CALIFORNIA COASTAL COMMISSION

December 21, 2000

**SUBJECT: STAFF RECOMMENDATION ON CITY OF SAN DIEGO MAJOR LOCAL
COASTAL PROGRAM AMENDMENT #4-2000 (CENTRE CITY—NORTH
EMBARCADERO OVERLAY DISTRICT)**

**PROPOSED
HIERARCHY OF STREETS**

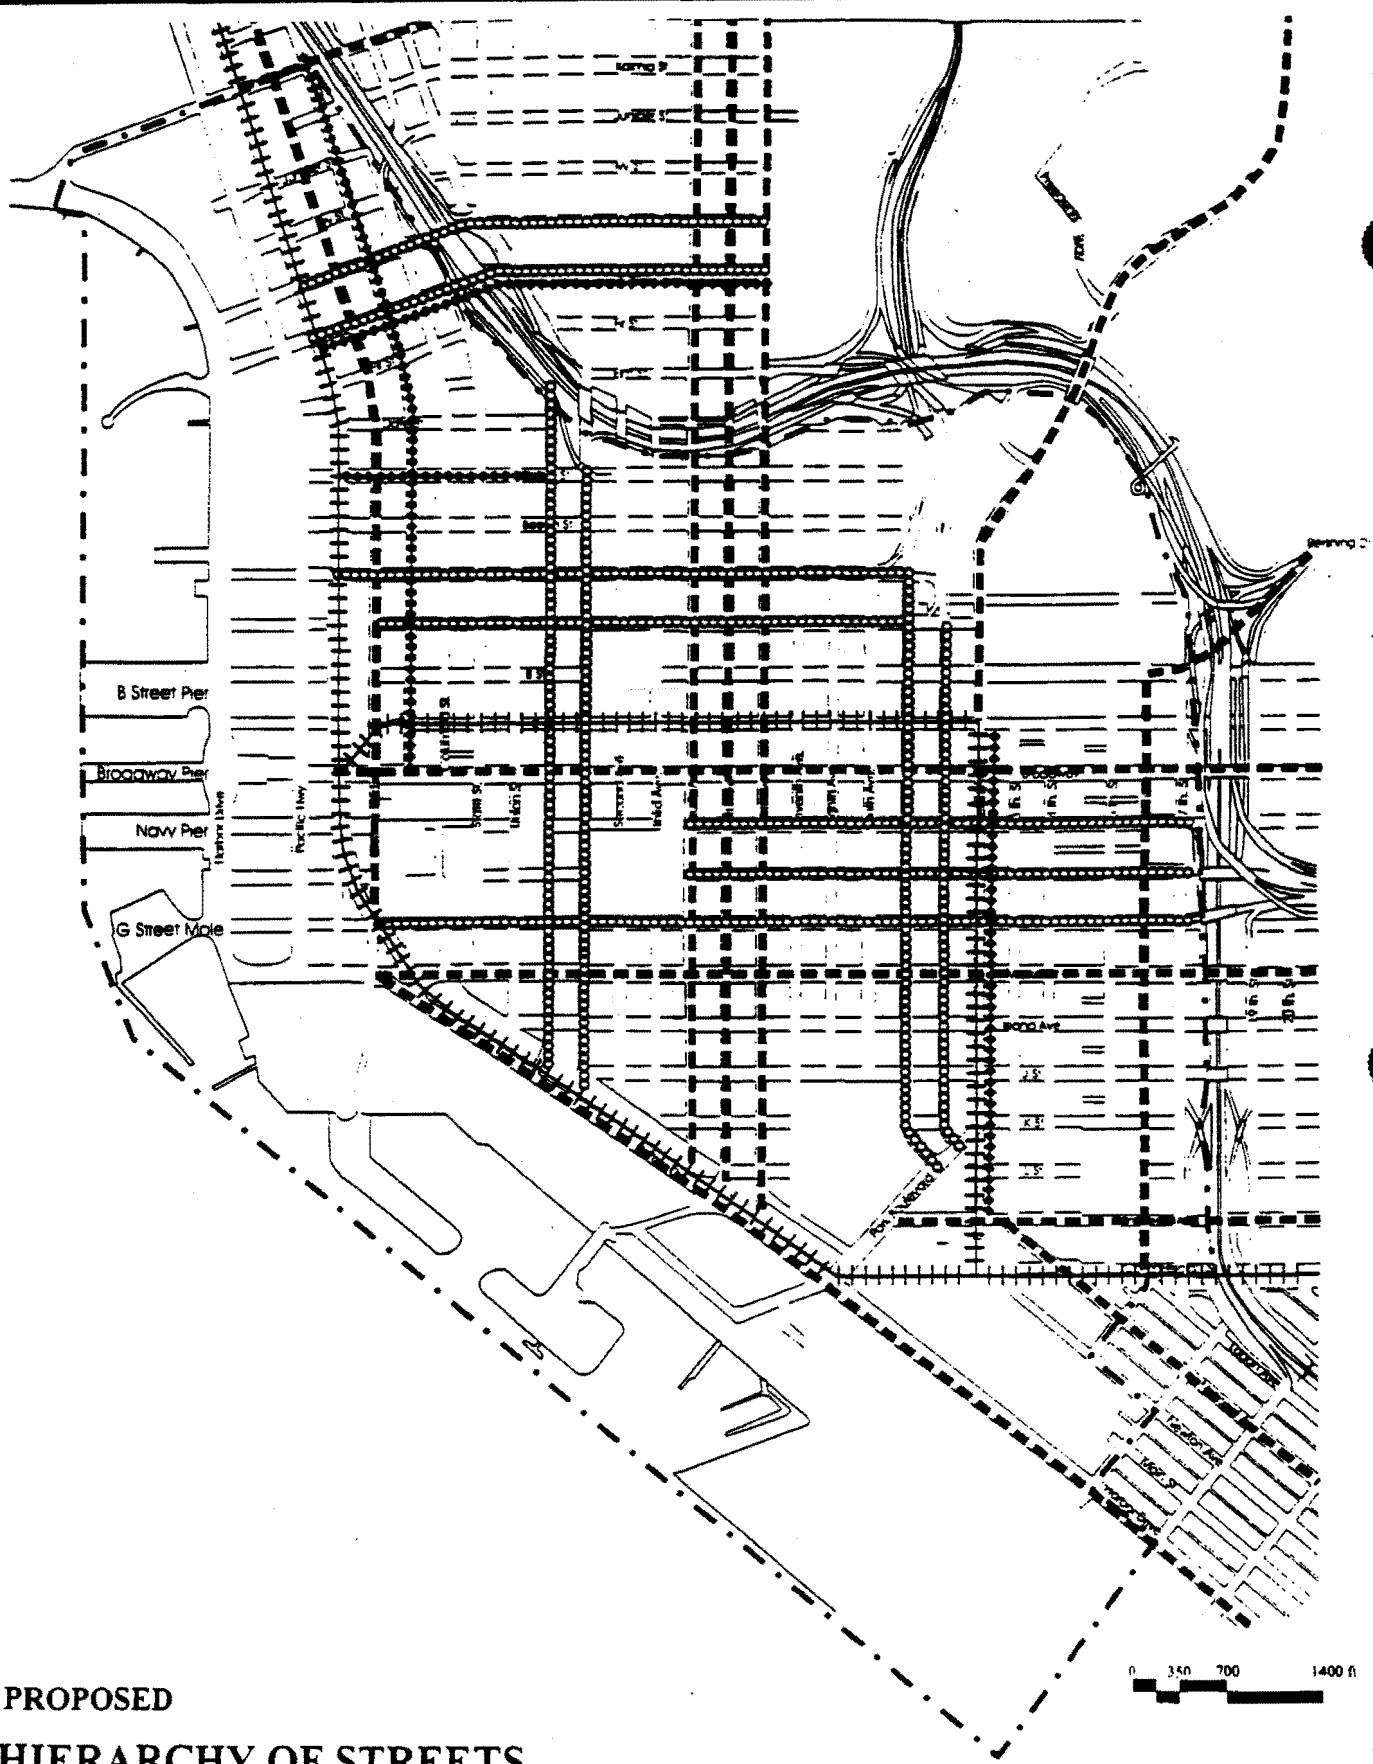
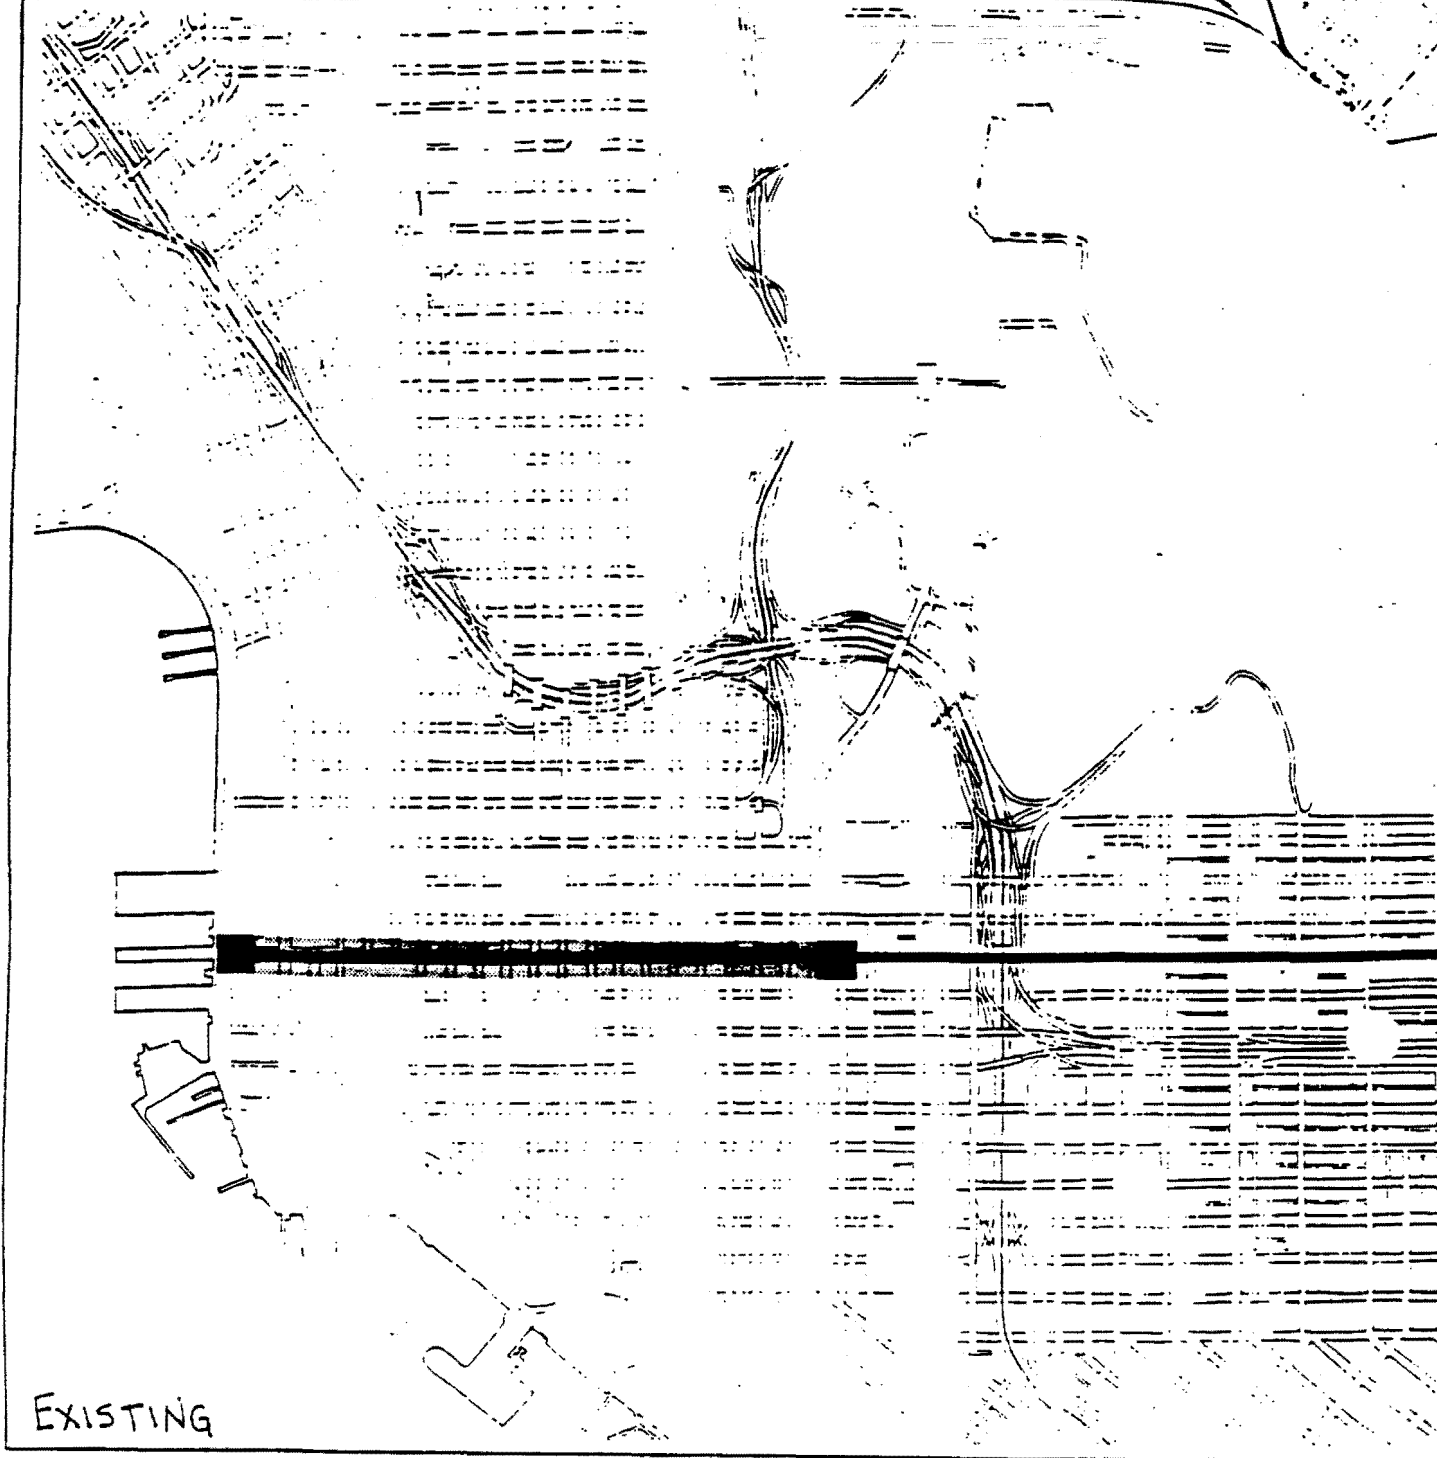
Figure 10, HIERARCHY OF STREETS exhibit in the existing Centre City Community Plan, which contains such designations as "District Center Streets" and "Crosstown Links", but as proposed, these designations would be removed from all streets within the North Embarcadero Overlay. The proposed language is generally consistent with the existing designations and does not remove any public access or visual protections currently provided by the existing plan.

**PROPOSED
VIEW CORRIDOR STREETS**

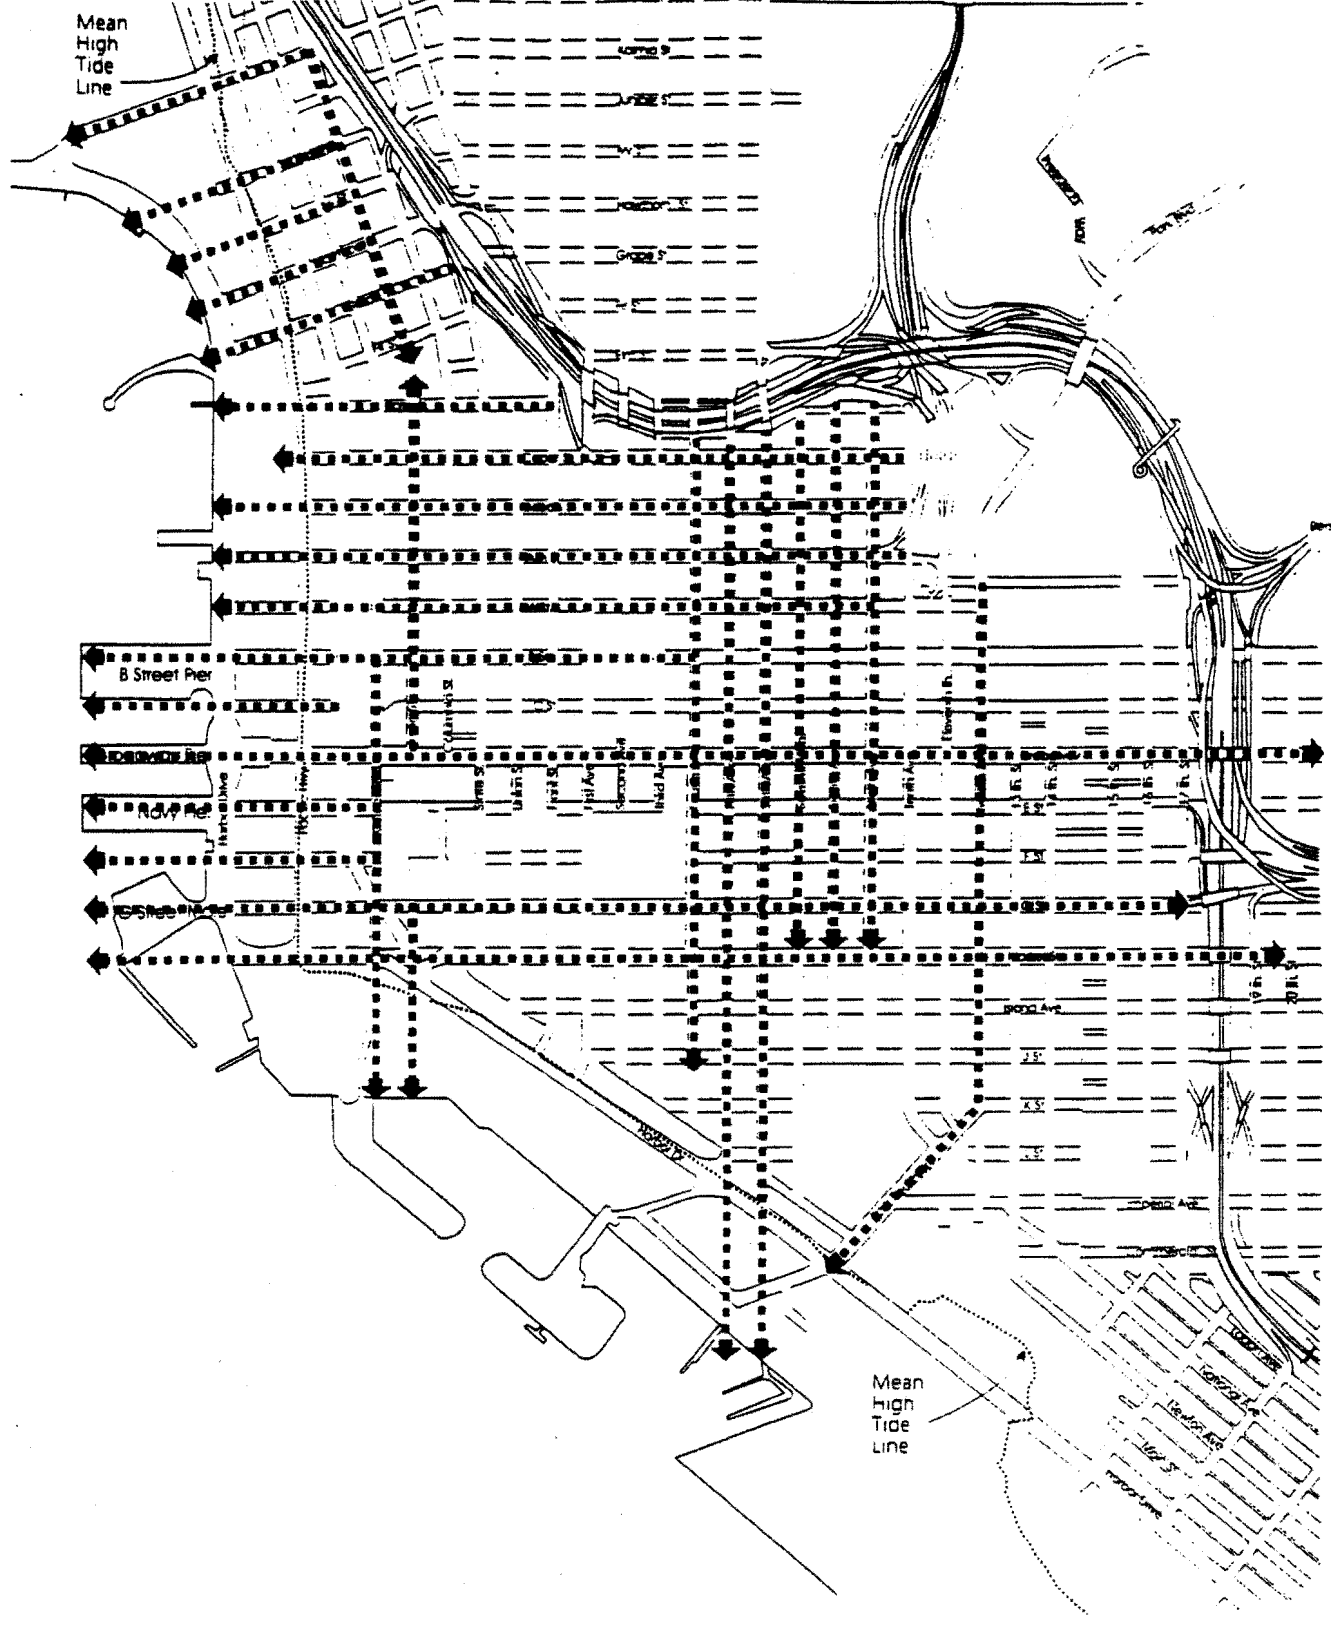
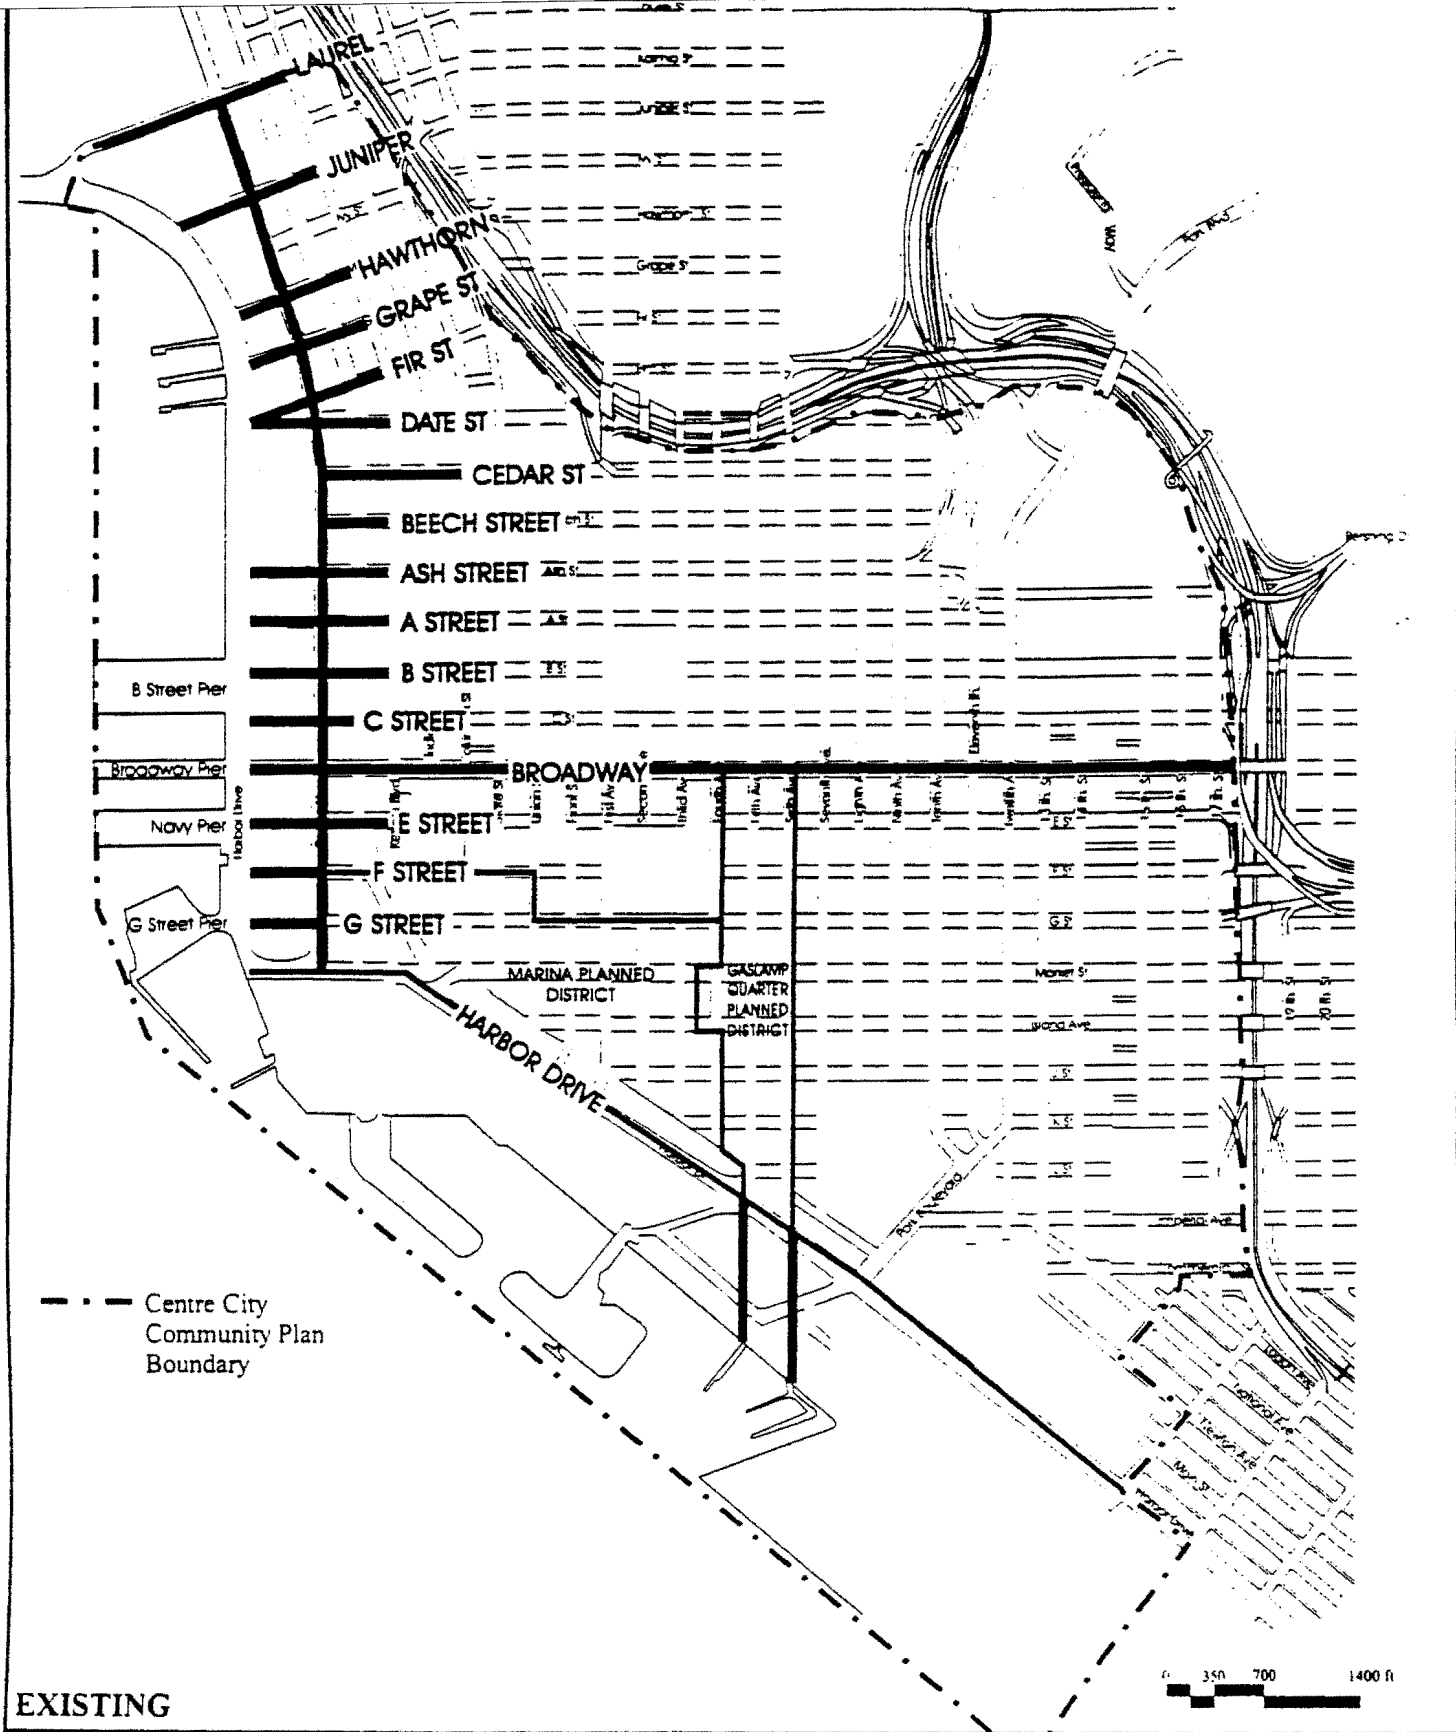
The plan would also make several changes to the existing View Corridors Streets shown on Figure 19. Ivy Street would be added as a View Corridor Street, and Pacific Highway is proposed to be removed as a view corridor. Designated view corridor streets are afforded special "stepback" protection to ensure that views from and along these streets are maintained. The plan would alter the required View Corridor Stepbacks for several streets west of California Street, including Juniper, Hawthorn, Grape, Cedar, ash, A, B, C, Broadway (both east and west of Kettner), E, F, and G.

3. Figure 19, **VIEW CORRIDOR STREETS**, shall be revised to graphically depict Pacific Highway as a View Corridor Street from Date Street south to Pacific Highway's terminus (as shown on the existing Figure 19).
4. The **VIEW CORRIDOR** Exhibit that includes stepbacks and stepback elevations shall be revised as follows:
